1					
Γ	REVISIONS							
	ZONE REV DESCRIPTION				DFTR	CHKR	DSNR	APPD
	32,3 32,3	•	CHANGED: WIRE NO. 33 WAS ∯18 AWG/GRY; WIRE NO. 34 WAS WAS ∯18AWG/BLU. DELETED: 1,2DE BETWEEN 1INST AND 1FS. ECO 14721	41800	BAJ	BAM		JMF
	D4	в	ADDED: GROUND WIRE NUMBER 39. ECO 16236	70601	BAJ	DAV		JAS
	C4	C	ADDED: GROUND WIRE NUMBER 40. ECO 18681	2-18-05	JAS	BJ		JAS
	C3	D	CORRECTED: WIRE NO. 36/18/BLK WAS SHOWN AS 37/18/YEL. ECO 18635	3-16-05	BAJ	fenn	\	Jas

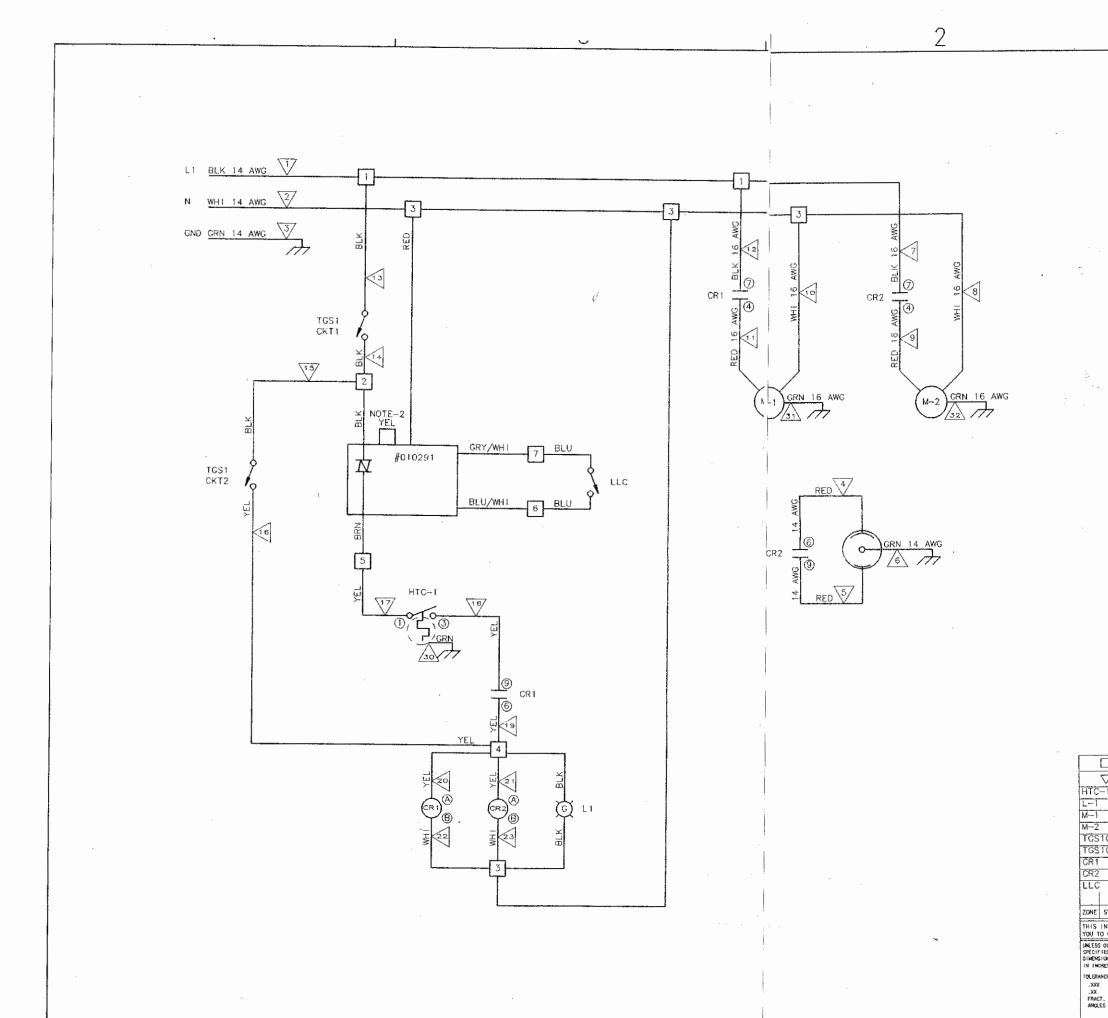
. 1				
1		REVISIONS				_
ZONE	REY	DESCRIPTION	DATE	BY	CHKD	1
	A	CHANGED LTC TO HTC PER RES	3-18-86	REM	×	ļ F
	B	ADDED TERMINAL STRIP	9-28-86	REM	×	
	с	ADDED LLC & TERMINAL STRIP TO NOMENCLATURE BLOCK.	8-4-87	MAD	ЧU	
	D	REDRAWN - ADDED WIRE IDENTIFIERS & NOTE-2.	1-17-89	JB	RJS	
	E	ADDED WIRE IDENTIFIERS 30, 31, & 32.	2-8-90	JB	RJS	Ŀ
	F	REMOVED: WIRES 24 AND 25 OFF "LLC" AND CONN. 7 & 5 [DOS10051].	2-27-93	РM	1. K
